Addendum No. 1

IFB-25-00072

Progress Village Fire Station No. 48

**Addendum No. 1
FOR
CONSTRUCTION
OF
PROGRESS VILLAGE SOUTH FIRE STATION No. 48**

RETAINING WALL
SCALE: 3/4" = 1'-0"

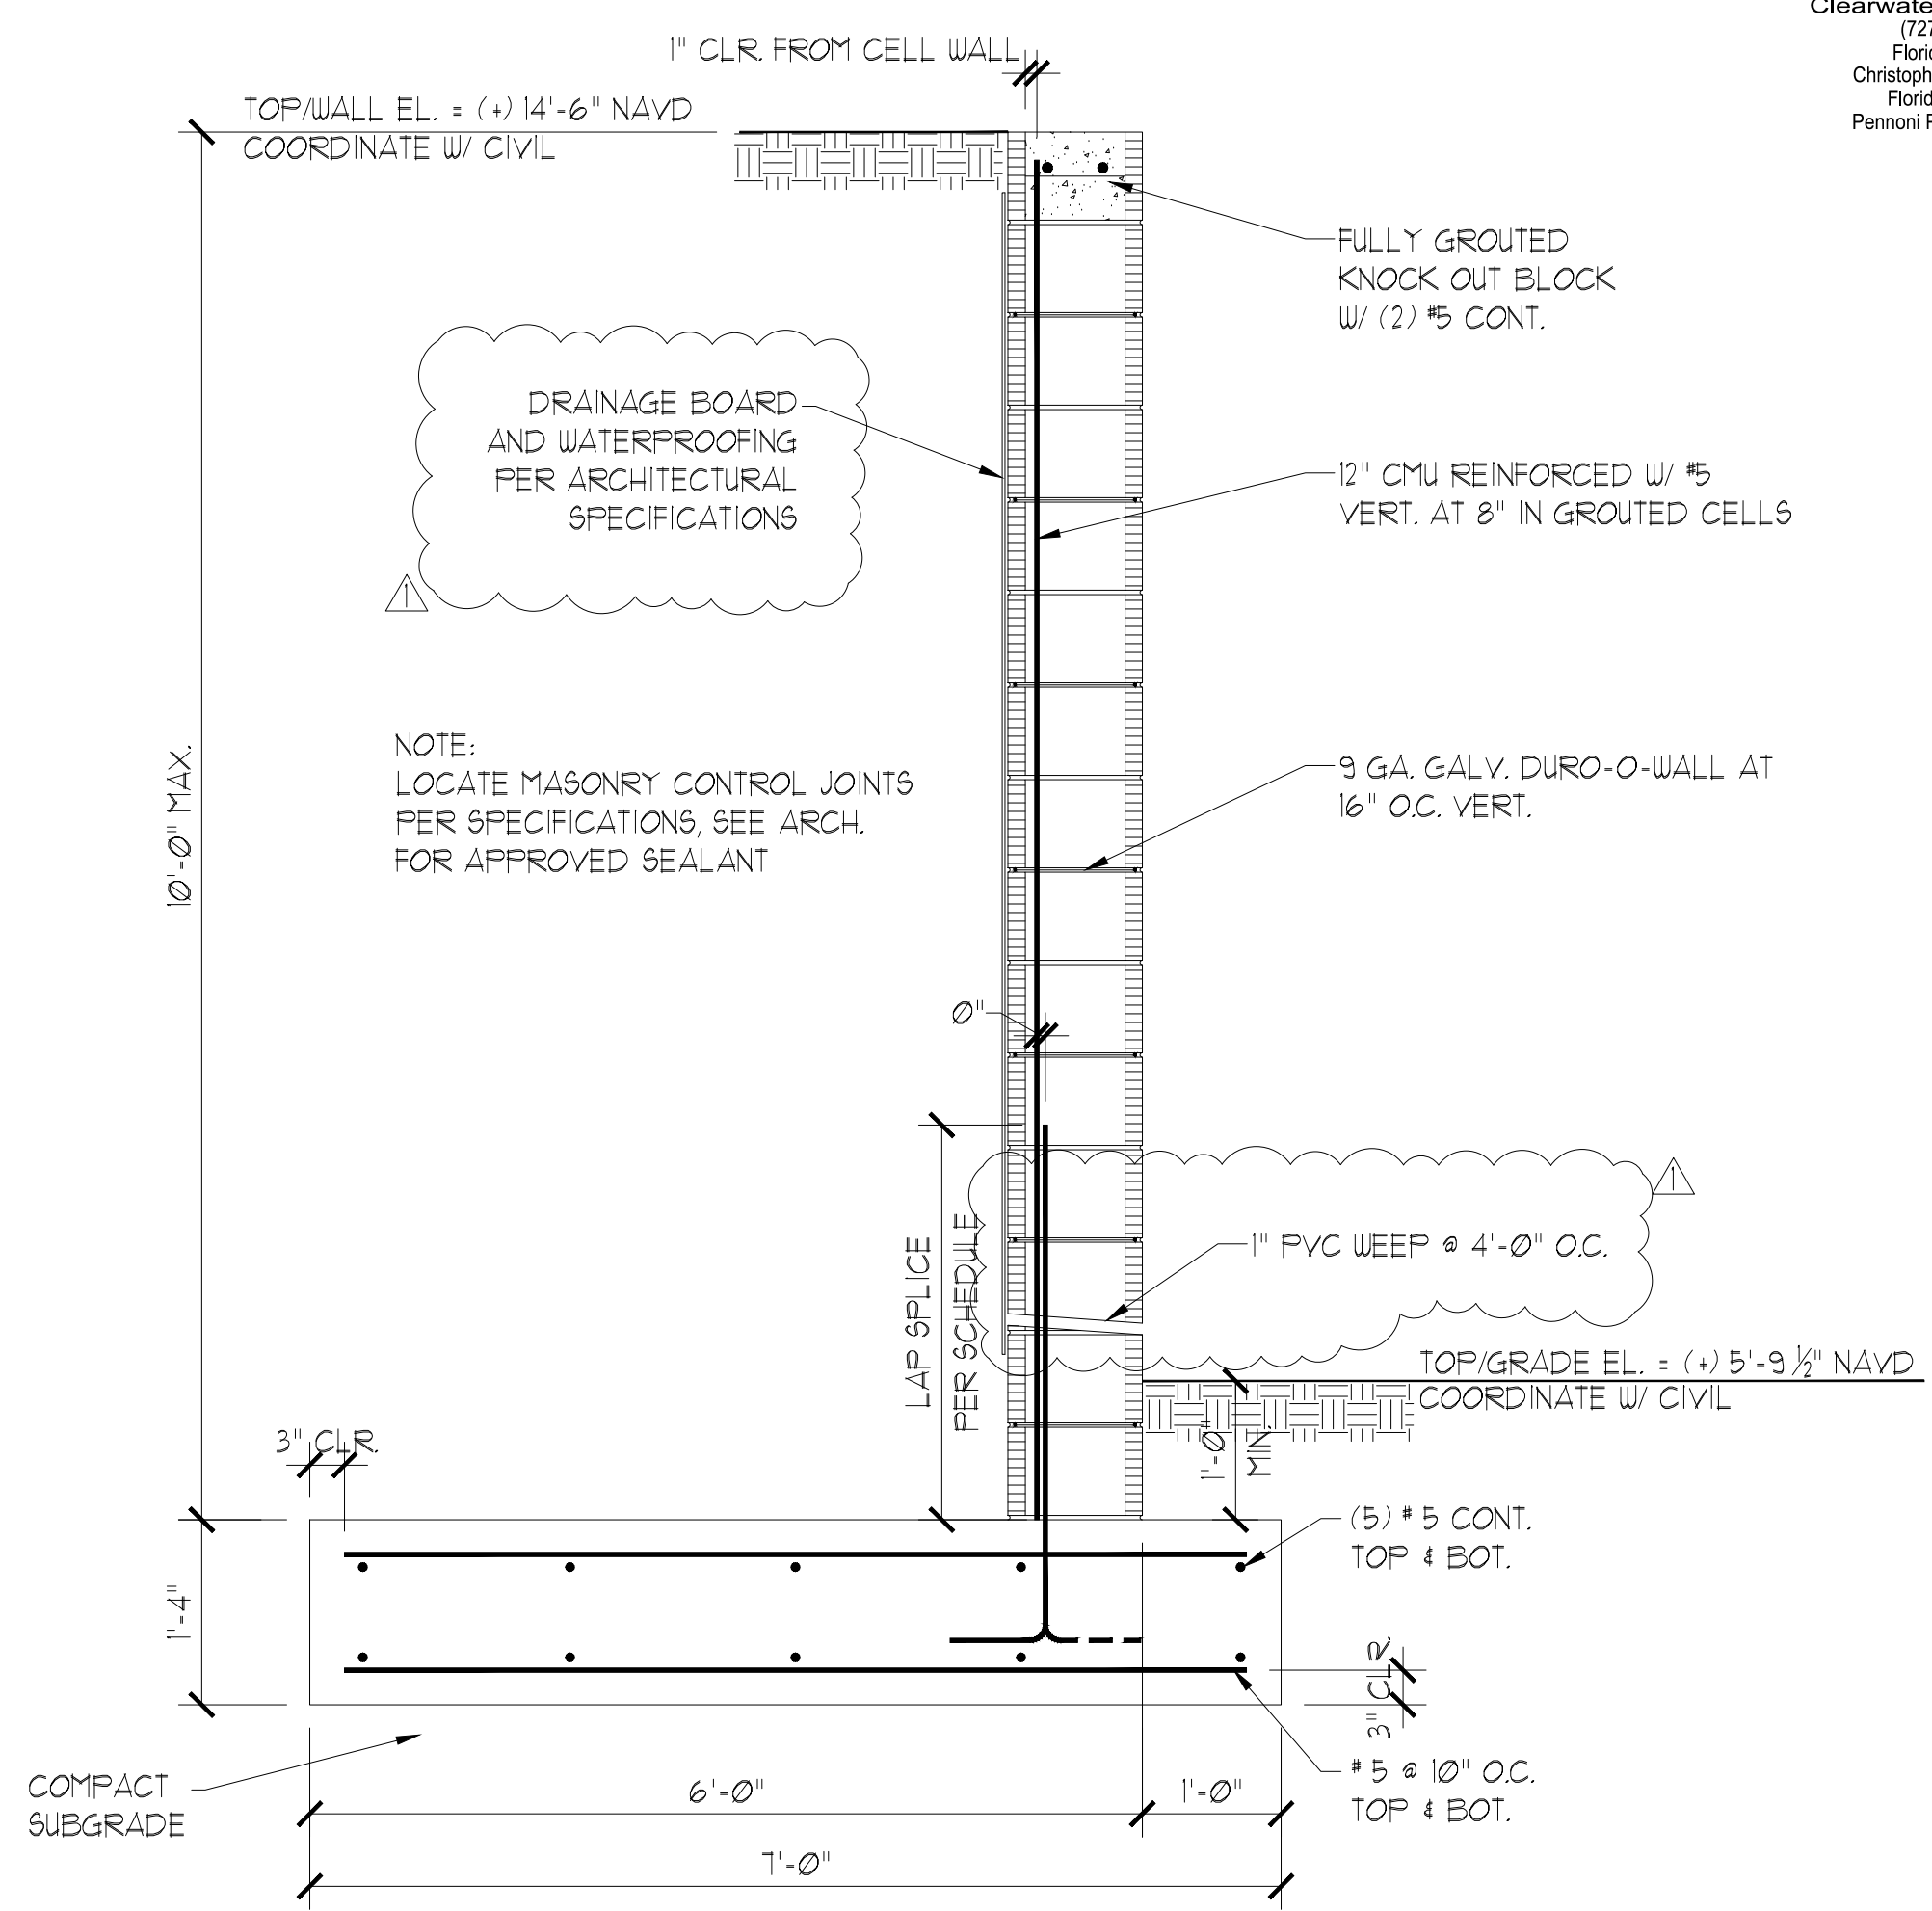
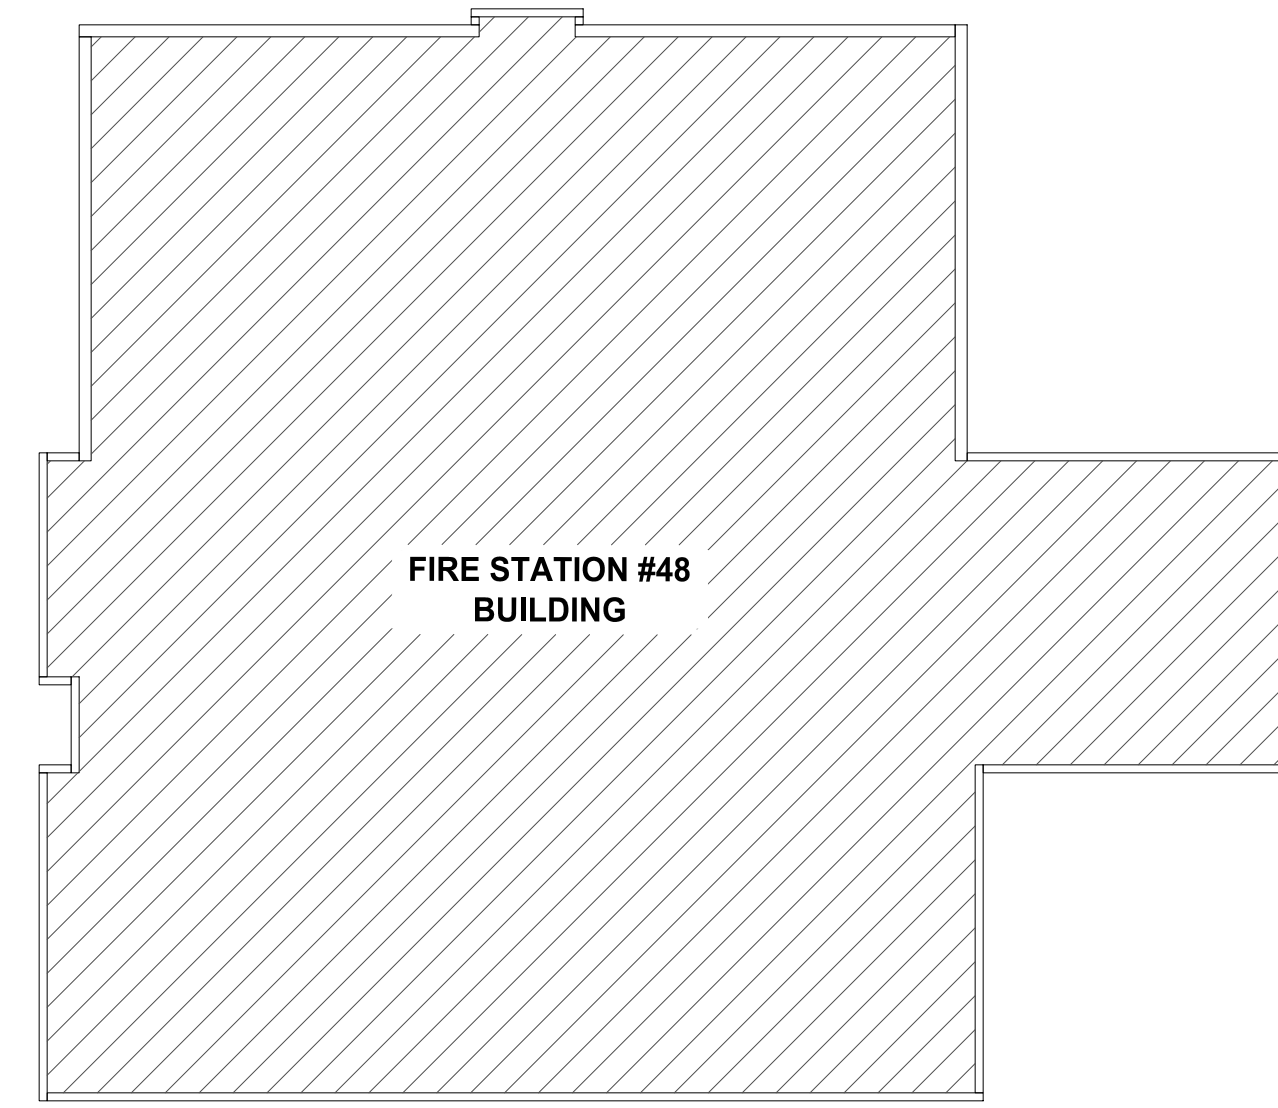
- a. Confirm the required top of footing elevation, since S1.0 shows 1' minimum whereas the Geotechnical Report implies the foundation should be much deeper.
- b. Specification for the 12" split face block noted per #45 on Sheet A1.0 including approved manufacturers, color, additives, etc. as necessary to fully describe the work.
- c. Specification for painting or water repellant coating for exposed surfaces.
- d. Masonry control joint details for the joints as laid out on Sheet S1.0 including expansion joint material, backer rod and sealant.
- e. Sheet waterproofing details at the control joints and the base of the wall to footing intersection.
- f. Drainage and/or protective board and any drain piping that may be necessary. Specification for backfill material other than onsite soils.

- a. The Geotech indicates a footing bearing depth of 24". We don't see any footings including the retaining wall that do not meet this recommendation.
- b. Use standard 12" CMU block at the retaining wall as indicated in structural drawings in lieu of split face masonry units.
- c. No painting or water repellant on exposed surfaces needed.
- d. Refer to detail 3 on S2.2
- e. Use W. R. Meadows DETAIL STRIP, a 9-inch-wide accessory product, to bridge control joints. Center the DETAIL STRIP over the control joint, adhering half (4.5 inches) to each side of the joint. Remove the release paper and press it firmly into place. Extend the strip at least 4.5 inches beyond any corners or terminations of the joint to ensure full coverage. These are based on the MEL-ROL product line. Provide similar detailing from other approved manufacturers.
- f. Refer to Addendum 01 revised detail 1 on S1.0

28. Replace sheet S1.0 SITE RETAINING WALL PLAN with dated 03.06.2025
